TRANSMISSION SEMINAR 1991

TRANSMISSION SEMINAR

Technical Service Information

Figure 47

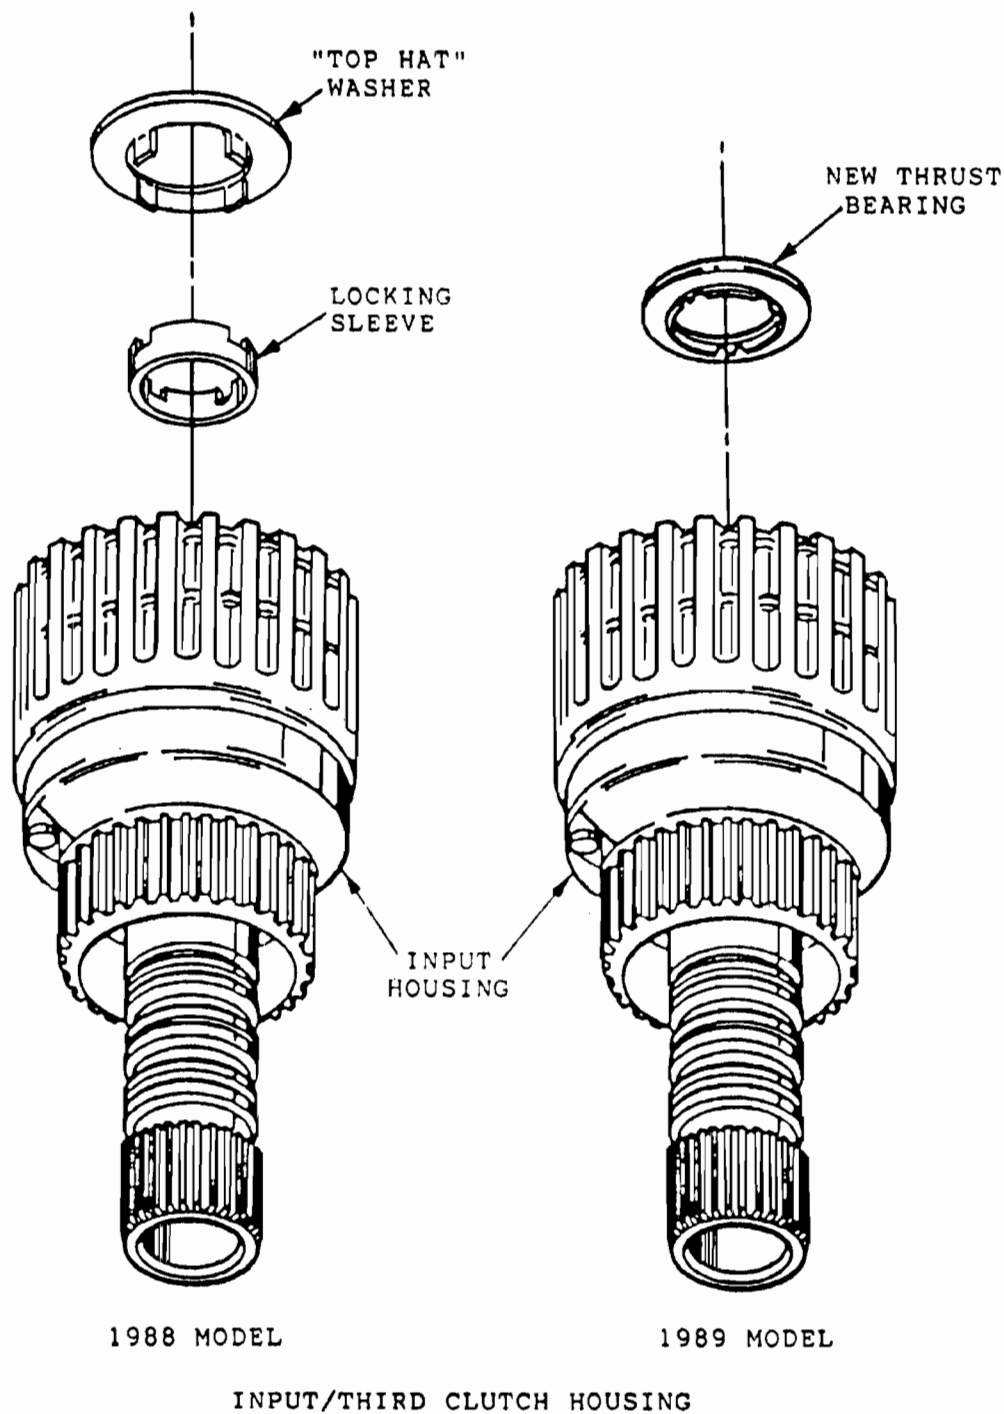
CHANGE: A new Thrust Bearing Assembly replaces the "Top Hat" Thrust Washer and Lock-up Sleeve in the input housing (See Figure 47) The new bearing and related parts went into production on all 1989 models on November 28, 1988 (Julian Date 333).

Figure 48

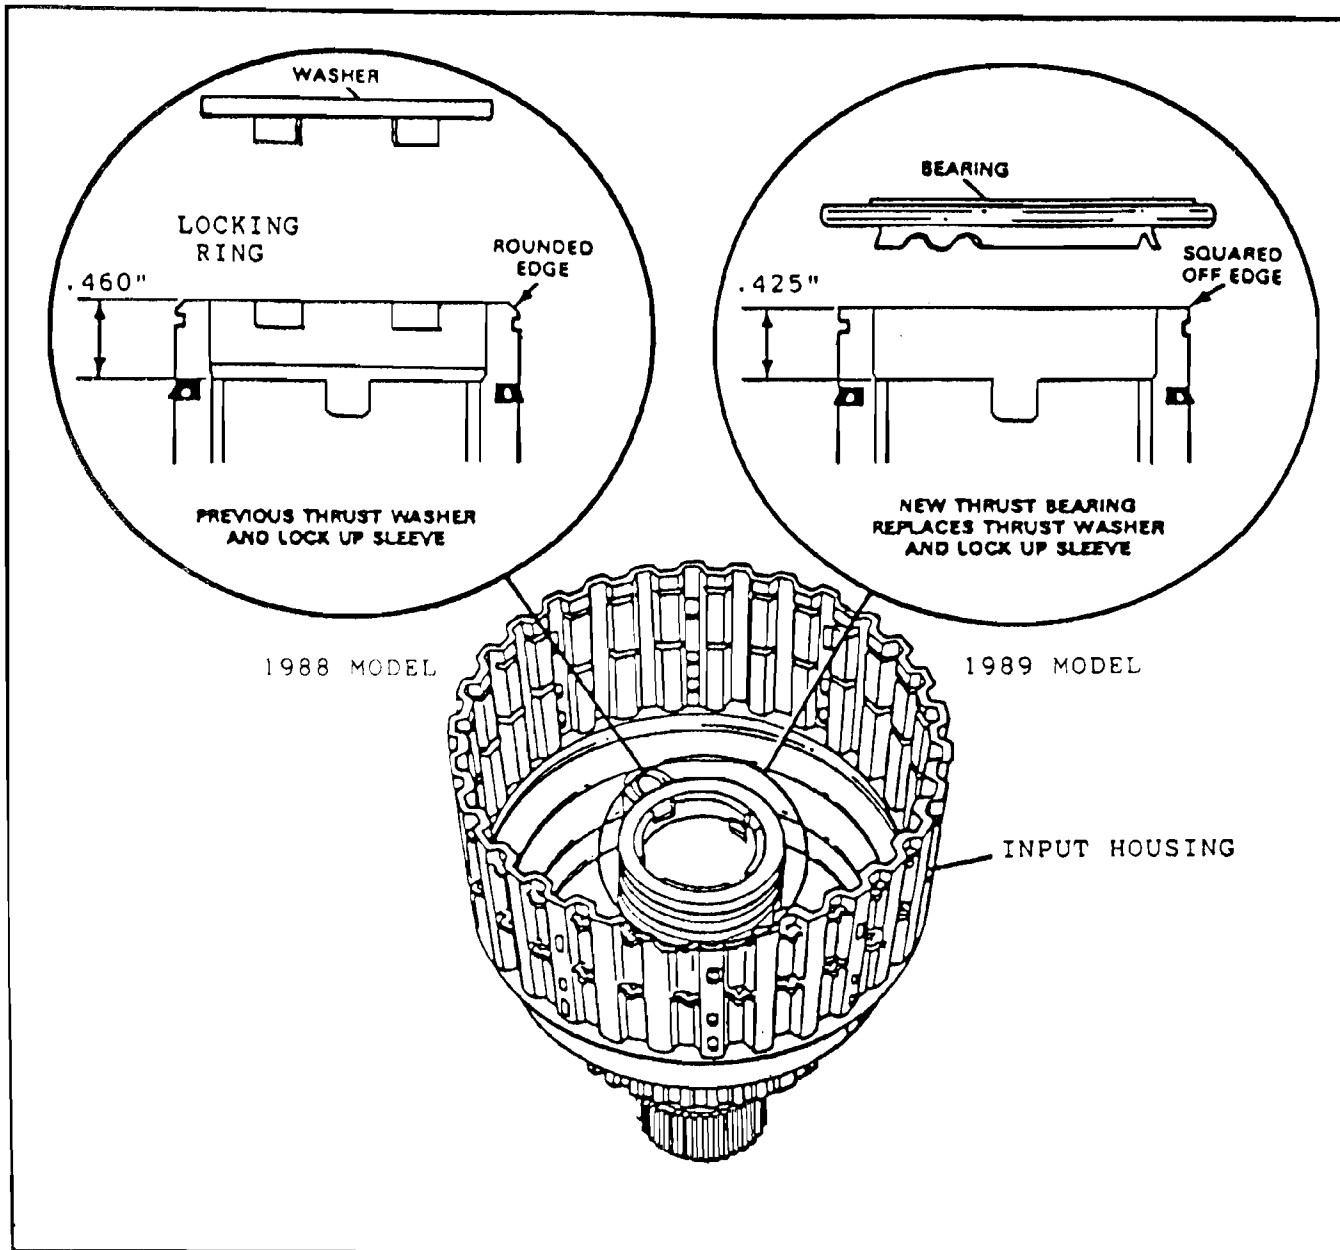
- (1) INPUT HOUSING - Surface on the input housing where the new bearing assembly rides, has been reduced by .035" to accomodate the increased thickness of the new bearing (See Figure 48).
- (2) "TOP HAT" THRUST WASHER - Eliminated (See Figure 48).
- (3) LOCK UP SLEEVE - The lock-up sleeve is no longer needed and has been eliminated (See Figure 48).
- (4) 3RD ROLLER CLUTCH LUBE DAM - The inside diameter has been increased by .256" to accomodate the larger diameter new bearing, and the lip on the lube dam eliminated for increased lube oil flow to the 3rd roller assembly (See Figure 49).
- (5) 3RD ROLLER CLUTCH INNER RACE - Has been machined .040" thinner to accomodate the increased thickness of the new bearing assembly (See Figure 49).

Figure 50

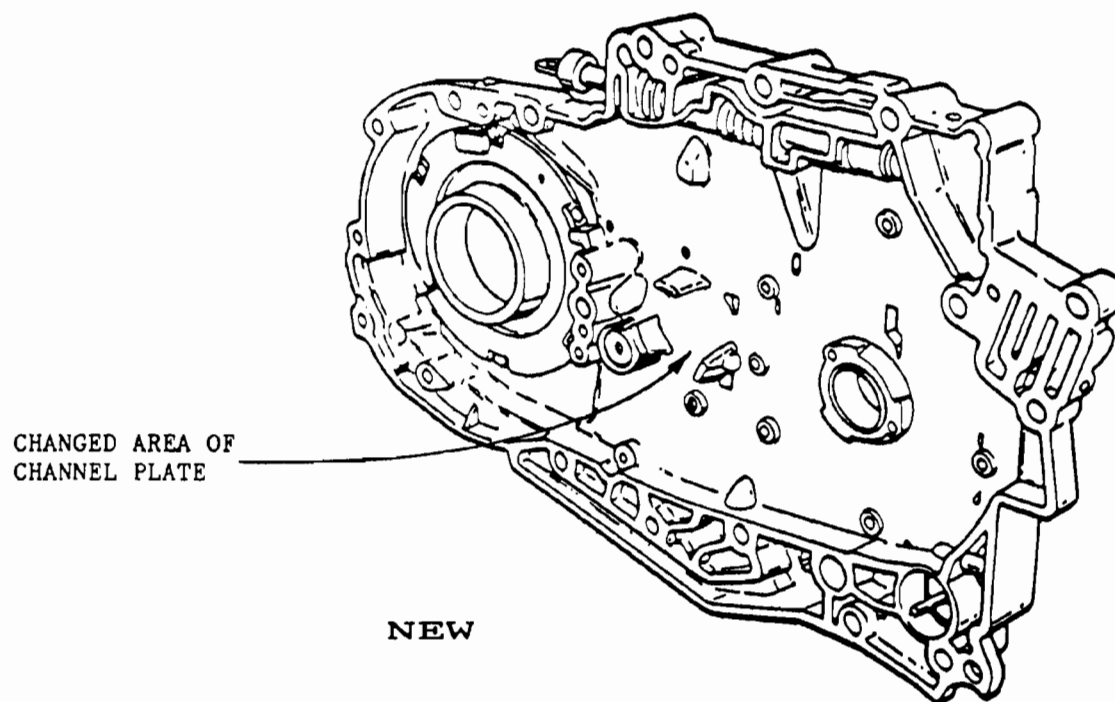
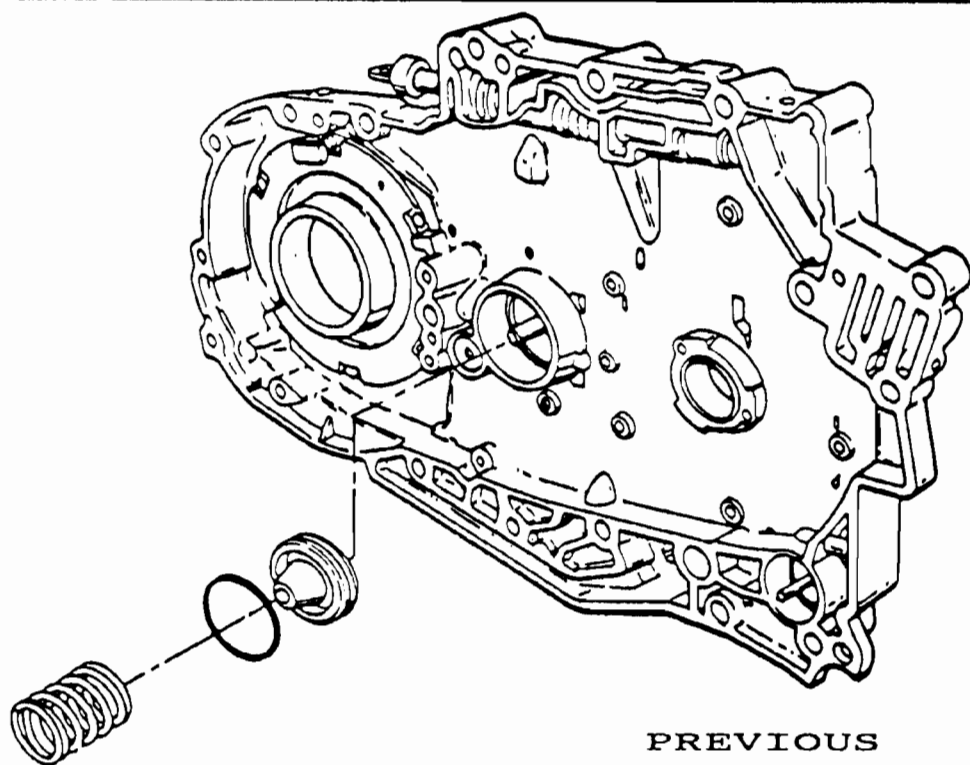
CHANGE: The Input Clutch Accumulator has been eliminated from the channel plate (See Figure 50).

- (1) CHANNEL PLATE - The input clutch accumulator piston, piston pin, and accumulator spring have been eliminated from the channel plate, which also changes the casting (See Figure 50).
- (2) INPUT HOUSING - Top snap ring groove moves .060" closer to the top of the input housing, to accomodate the added wave plate (See Figure 51).
- (3) INPUT CLUTCH STEEL PLATES - The steel plates are .027" thinner to accomodate the added wave plate (See Figure 52). The new steel plates are .049" thick, and the old steel plates are .076" thick.
- (4) INPUT CLUTCH "STACK" - The input clutch stack has been revised to accomodate the new changes. Refer to Figure 52 for proper assembly of the new input clutches.

Figure 53

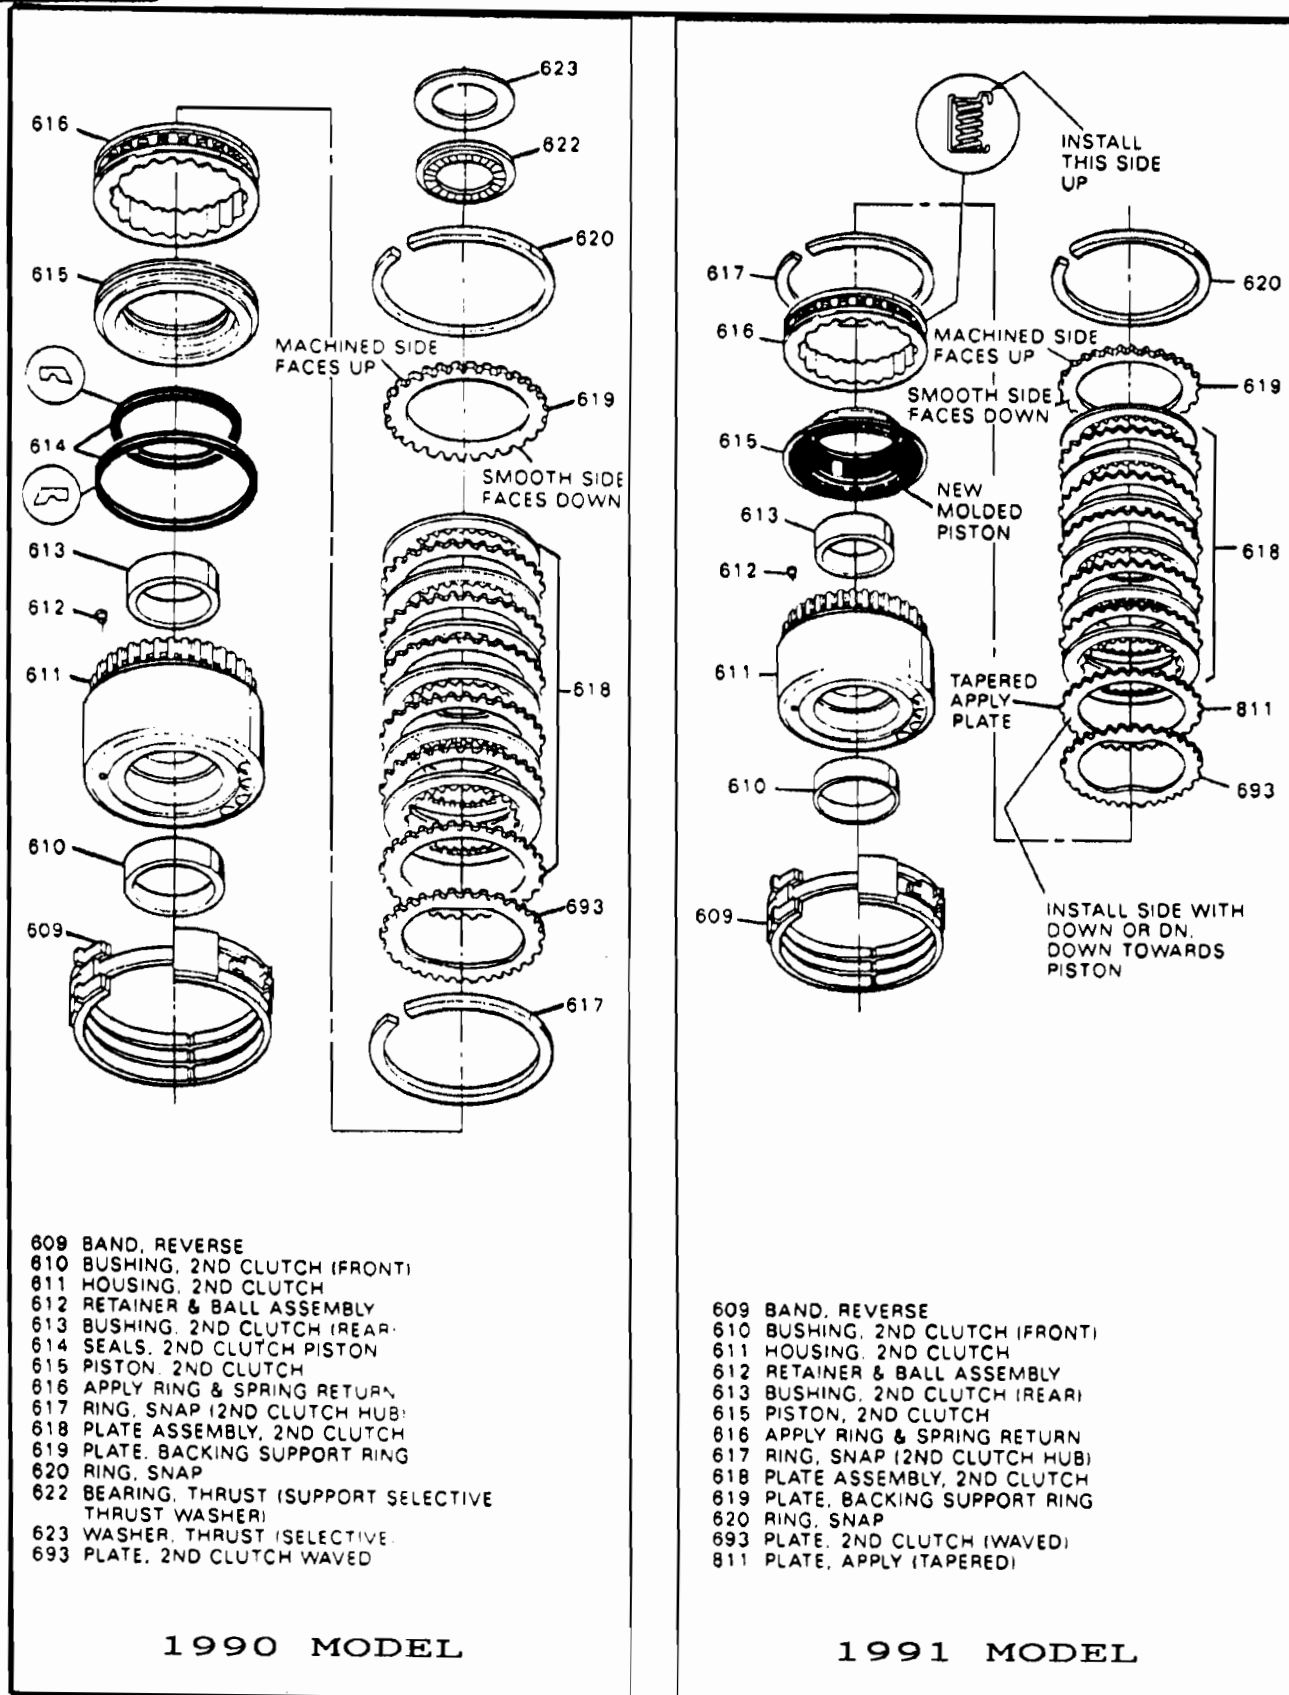
- (1) 2ND CLUTCH HOUSING - Snap ring grooves moved and revised clutch stack up, along with dimensional changes on the center journal area so as to accomodate the new moulded piston and seal assembly (See Figure 53).
- (2) 2ND CLUTCH PISTON - Now has moulded seal assembly on the piston (See Figure 53).
- (3) APPLY RING AND RETURN SPRING ASSEMBLY - Revised dimensions to accomodate the new moulded piston assembly, and the revised clutch stack-up. (See Figure 53).
- (4) REVISED CLUTCH STACK - Includes a new "Apply" plate in the stack-up and one less "Koline" steel plate (See Figures 53 and 55).

Figure 56

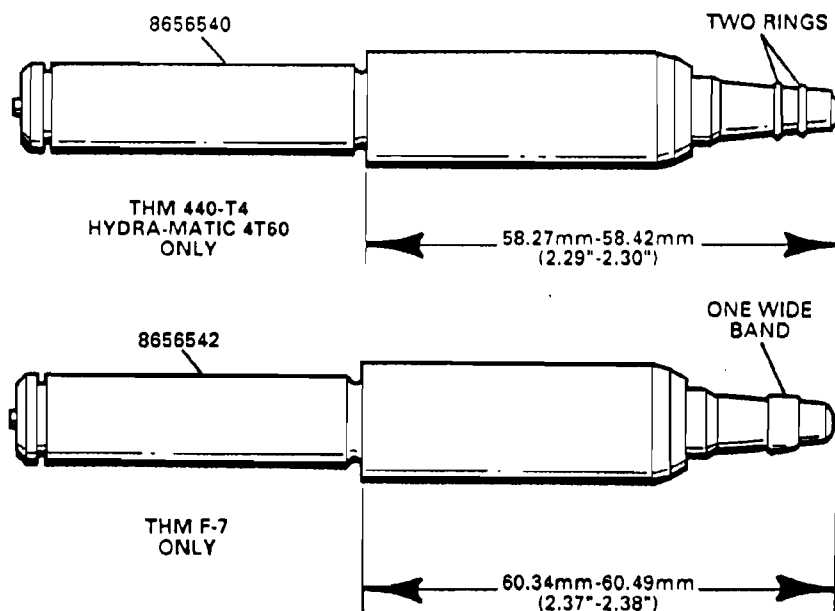
- (1) 1-2 BAND ASSEMBLY - A new manufacturing process machines the area where the case anchor pins contact the band (See Figure 56). With this new process, all of the 1-2 bands are the same size, and the selective band apply pins are eliminated.
NOTE: THE 1-2 BAND STOP LOCATED IN THE BARREL OF THE CASE (ON MODELS SO EQUIPPED) MUST BE REMOVED AND DISCARDED WHEN USING THE NEW BAND.

The new 1-2 band assembly will retro-fit back to all previous models, with the proper band apply pin installed (See Figure 56).

Figure 57

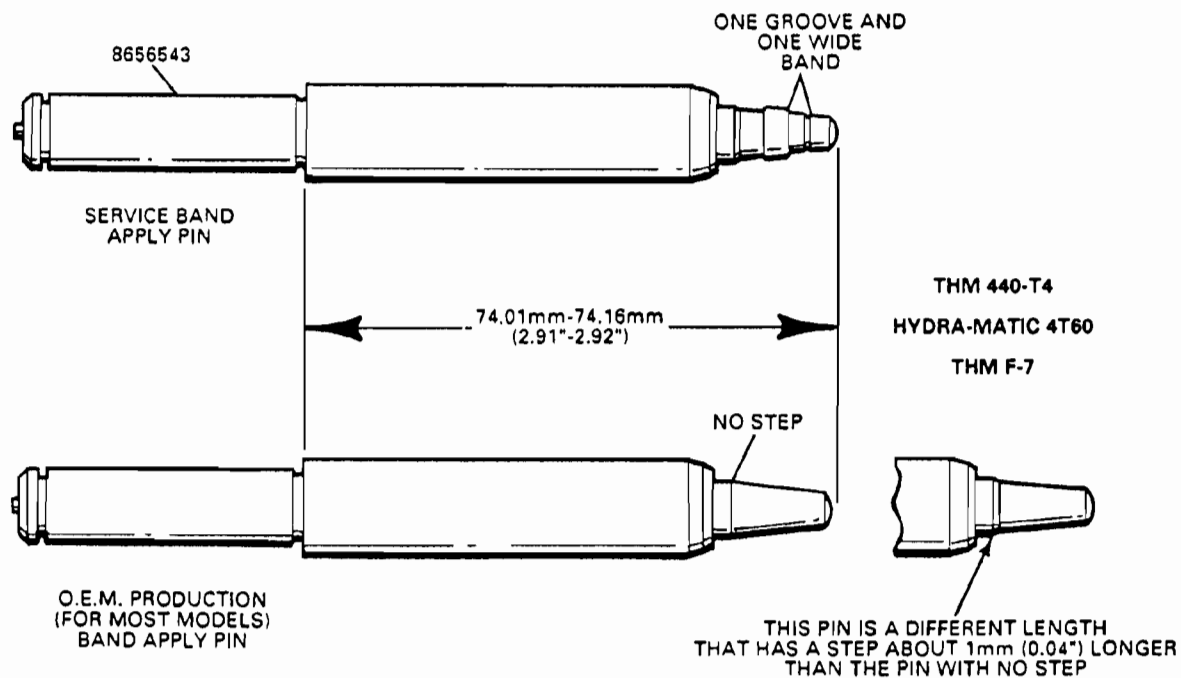
- (2) REVERSE BAND ASSEMBLY - A new manufacturing process machines the area where the case anchor pins contact the band (See Figure 57). With this new process, all of the reverse bands are the same size, and selective band apply pins are eliminated. The new reverse band also has the new friction material to help decrease reverse engagement concerns.

The new reverse band assembly will retro-fit back to all previous models, with the proper band apply pin (See Figure 57), and it also has the new friction material to help decrease reverse engagement concerns.
